# Review Panel Report

## San Joaquin River Valley CalSim II Model Review

CALFED Science Program – California Water and Environment Modeling Forum

**12 January 2006**

**Figure B5. Flow versus ( $\mu\text{S}/\text{cm}$ ) data for Maze**

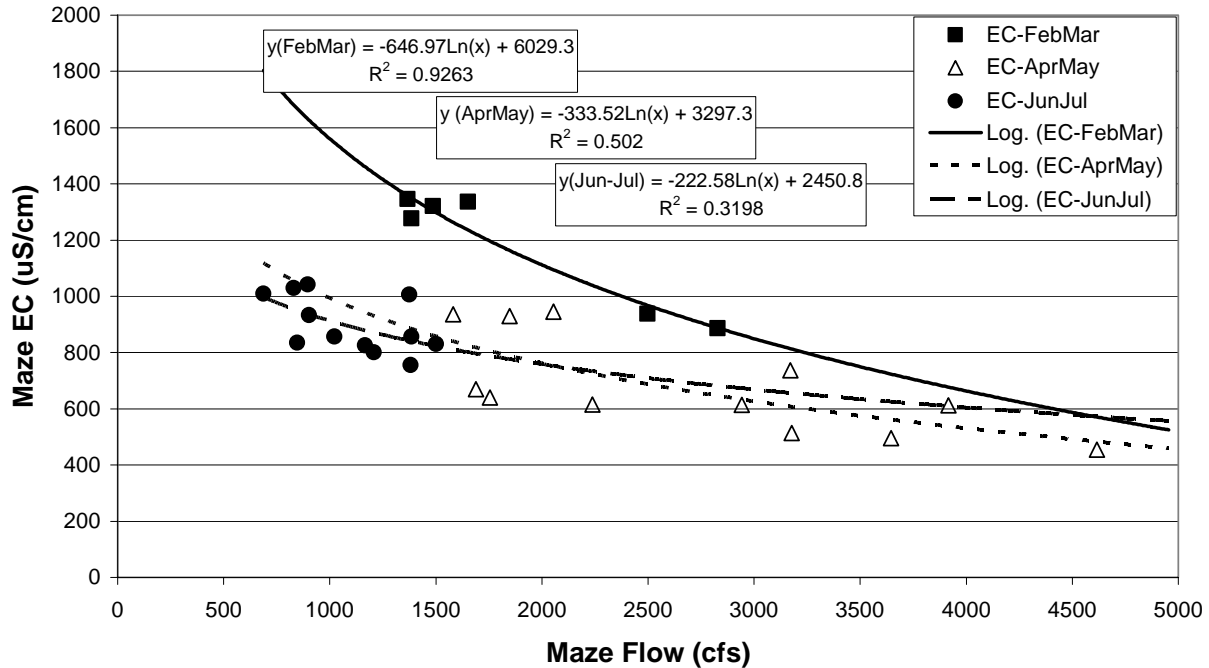
The following graphic illustrates why the second type of error is important. Figure B5 is a copy of the figure presented as slide 37 in the Microsoft PowerPoint™ presentation of the water quality module presented to the panel on 4 August. This figure contains regressions used to resolve the load residual term at Maze for three time periods: February to March; April to May; and June to July. Data for flows exceeding 5,000 cfs were omitted to allow for better resolution of the low flows. The regressions approximate a mean water quality condition for a range of flows. The error that use of such a regression may impart on a regression-estimated EC can be

seen by considering the regression estimated EC for a flow of 2,050 cfs using the April to May curve. The regression estimates an EC of approximately 750  $\mu\text{S}/\text{cm}$  whereas the EC for a flow of 2,000 cfs was actually 945  $\mu\text{S}/\text{cm}$  (data pair of 945  $\mu\text{S}/\text{cm}$  and 2,055 cfs).

In this example, reliance on only the mean value, without consideration of the variability in the actual system, results in an underestimate of approximately 200  $\mu\text{S}/\text{cm}$ , unless this effect is linearly counterbalanced by other potential realizations. As has already been shown in previous examples, underestimates of this magnitude will contribute to a consistent underestimate in the potential need for releases from New Melones.
